Contract # : **04-0120E4**
Cty **SF** Rte **80** PM **13.4/13.8.**
File # **45.25 B**

QUALITY ASSURANCE - NONCONFORMANCE REPORT

NCR #107

Subject: Response to RFI No. 286, Revision No. 00 (KOS RFI 50 - Buttering of T1 Diaphragm P95)

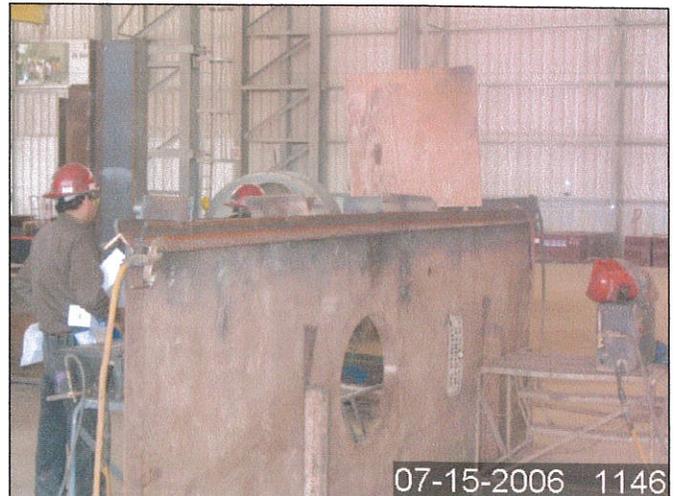
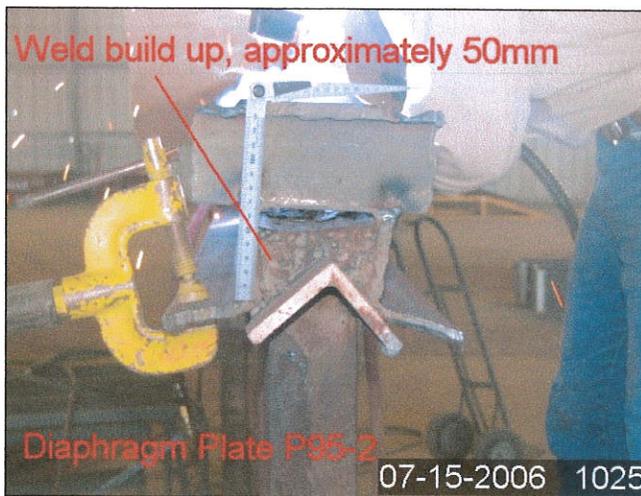
- 1.) KOS Quality Control (QC) Representative allowed KOS to build up diaphragm plate P95-2 by welding for the full length of 5320mm and a depth of approximately 50mm without prior approval from the Engineer.
- 2.) KOS Quality Control (QC) Inspector was not aware that KOS was welding on the identified diaphragm plate until the Caltrans Quality Assurance (QA) Inspector brought it to his attention at approximately 1045 hours. The shift on this date began at 0700 hours.
- 3.) The Caltrans QA Inspector measured the interpass temperature at KOS welder Mr. Pecina's station and found that it did not meet the minimum requirement of 107 degrees Celsius, using a 107 degree Celsius temperature indicating crayon.

Applicable reference: 1) AWS D1.5 2002 section 3.3.4.2 "Root openings larger than those allowed in 3.3.4.1 may be corrected by welding only with the approval of the engineer." Section 3.3.4.1 states "Root openings larger than those allowed in 3.3.4, but not greater than twice the thickness of the thinner part or 20 mm [3/4 in.], whichever is

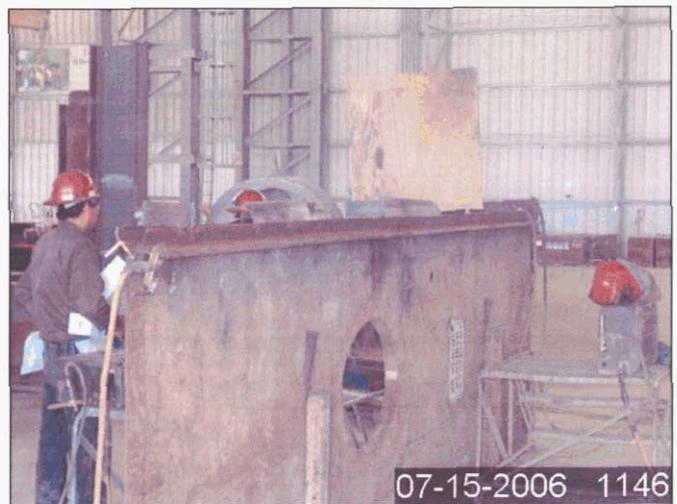
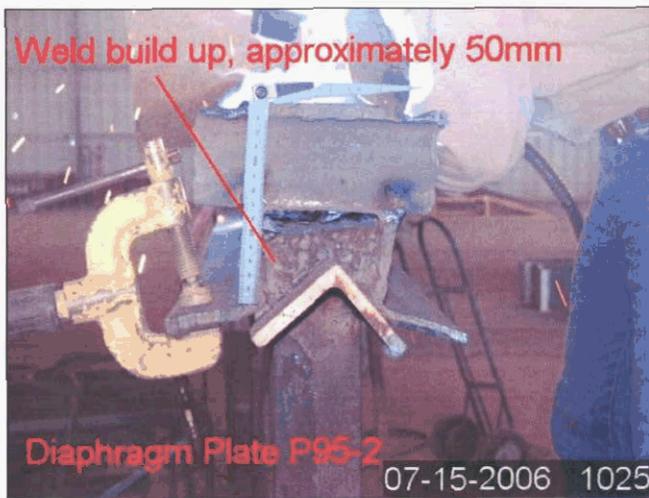
- 1.) KOS Quality Control (QC) Representative allowed KOS to build up diaphragm plate P95-2 by welding for the full length of 5320mm and a depth of approximately 50mm without prior approval from the Engineer.
2.) KOS Quality Control (QC) Inspector was not aware that KOS was welding on the identified diaphragm plate until the Caltrans Quality Assurance (QA) Inspector brought it to his attention at approximately 1045 hours. The shift on this date began at 0700 hours.
3.) The Caltrans QA Inspector measured the interpass temperature at KOS welder Mr. Pecina's station and found that it did not meet the minimum requirement of 107 degrees Celsius, using a 107 degree Celsius temperature indicating crayon.

Applicable reference: 1) AWS D1.5 2002 section 3.3.4.2 "Root openings larger than those allowed in 3.3.4.1 may be corrected by welding only with the approval of the engineer." Section 3.3.4.1 states "Root openings larger than

RFI No. 286, Revision No. 00, pertains to Kiewit Offshore Service's (KOS) request to butter diaphragm plate P95 of the Pier T1 footing by adding 18mm to the original length. Regarding this RFI, the Department takes no exception to the request. However, the following shall be provided:

1. Both magnetic particle testing and ultrasonic testing of the buttered areas shall be performed as required by AWS D1.5:2002, Section 6.7.3.
2. Rejectable indications located in the buttered area during the nondestructive testing of the completed weld shall not be considered base metal indications and shall be repaired in accordance with the AWS D1.5:2002.
